YANMAR SERVICE NEWS

Subject	MET18 Turbocharger LO Leakage	No.: 16-2-G-08-012-O Aug. 2016	
Engine Model	6EY18(A)L(W)	Use	Marine Aux. Engines, Industrial
		Engine Nos.	_____

In the 6EY18 engines, LO leaked from the joint face of the MET18 turbocharger exhaust casing and the center cartridge.

Photo 1. LO Leakage

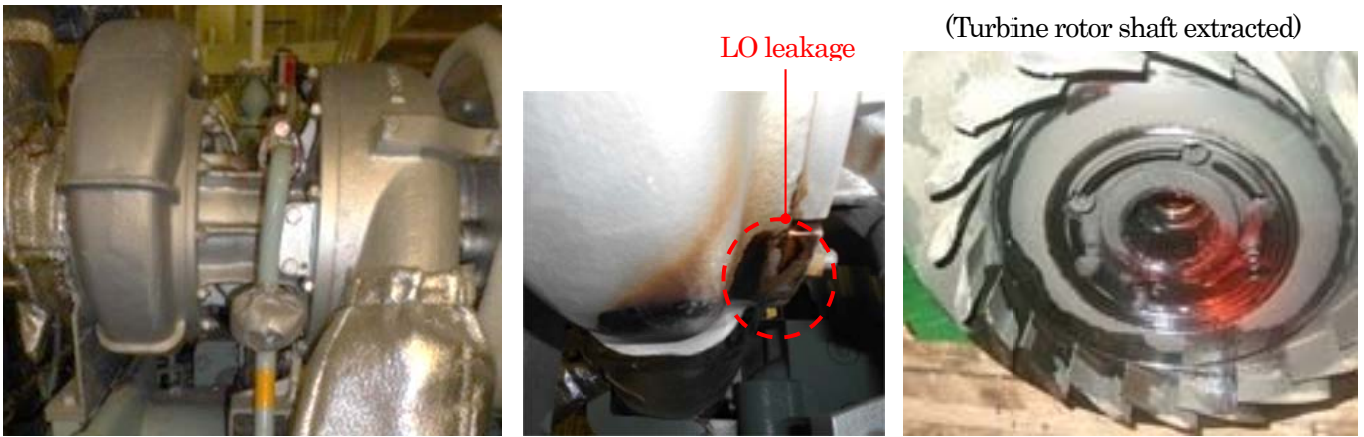
We noted that lube oil seemed to have leaked more heavily downward. This suggests that lube oil continued to leak while the engine was being stopped, too. This is because of the draft effect of the exhaust pipe of the engine being stopped.

Fig.1 MET18 Turbocharger Section

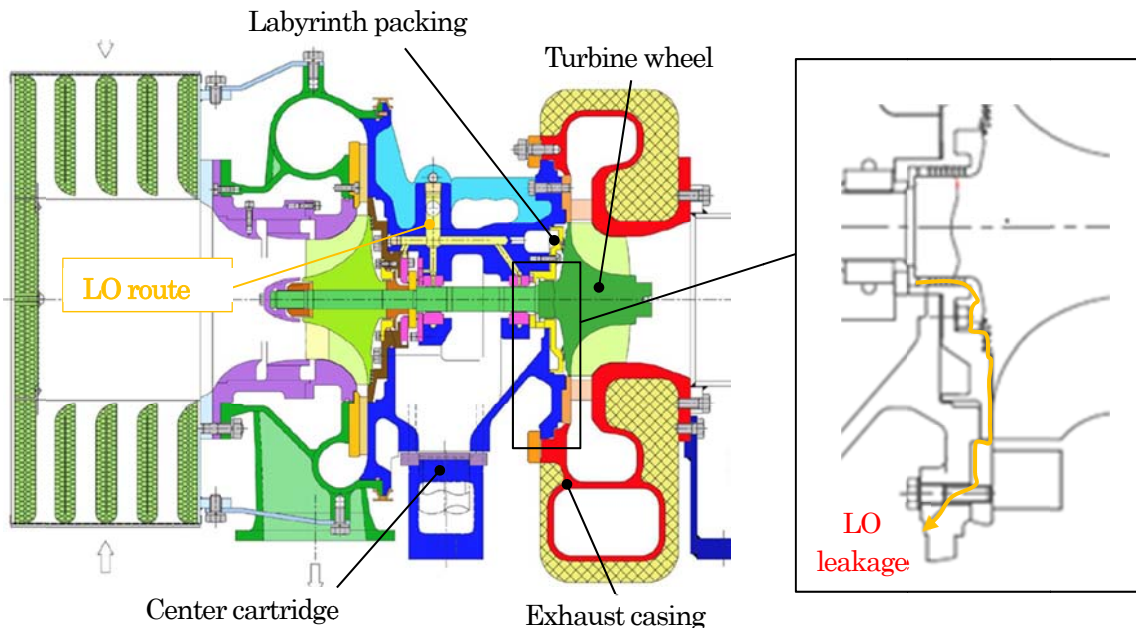
Upon inspection, we found that lube oil leaked from the turbine-side rotor shaft seal,(labyrinth packing).

Fig.2 Sealing Air Route of MET18Turbocharger

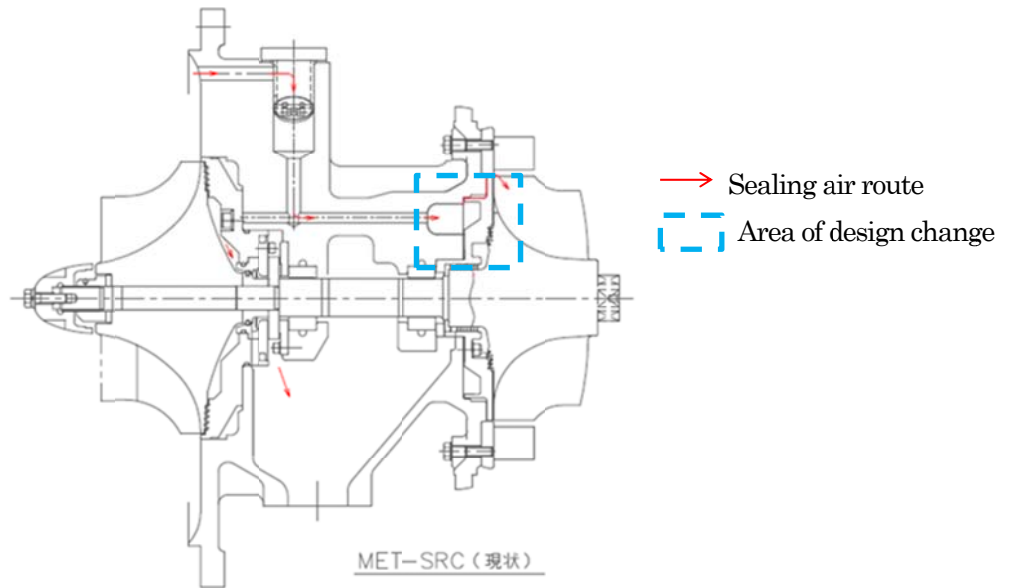
Mitsubishi Heavy Industries Marine Machinery & Engine Company, the manufacturer, as a result of examining the status above, has changed the design of the labyrinth packing: In order to prevent the sealing performance from lowering and to maintain the sealing capacity longer, the seal air hole was added to the labyrinth packing for sealing by pressurized air. (Applicable Engine No.7719~)

Conventional type	Improved type
Design Change		<p>In order to improve sealing performance during operation, the seal air hole was added so that the air pressurized by ventilation while the engine is being stopped flowing to the labyrinth prevents generation of negative pressure.</p>
Discrimination		<p style="text-align: center;">(○) Addition of sealing air holes (4 positions)</p>

In this relation, if LO leaked in your turbocharger in a very short time, we recommend the improved labyrinth packing for your use.

Part No.	Engine Model	Remarks
146623-19310	6EY18(A)L	Turbocharger Serial No.90000~
146623-19300		Turbocharger Serial No.80000~89999
146621-19310	6EY18AL(W)	Turbocharger Specs. "S" at the end for ID e.g. : FU1K23DCW111KJ35MS
146621-19300		Turbocharger Specs. No "S" at the end e.g. : FU1K23DCW111KJ35M
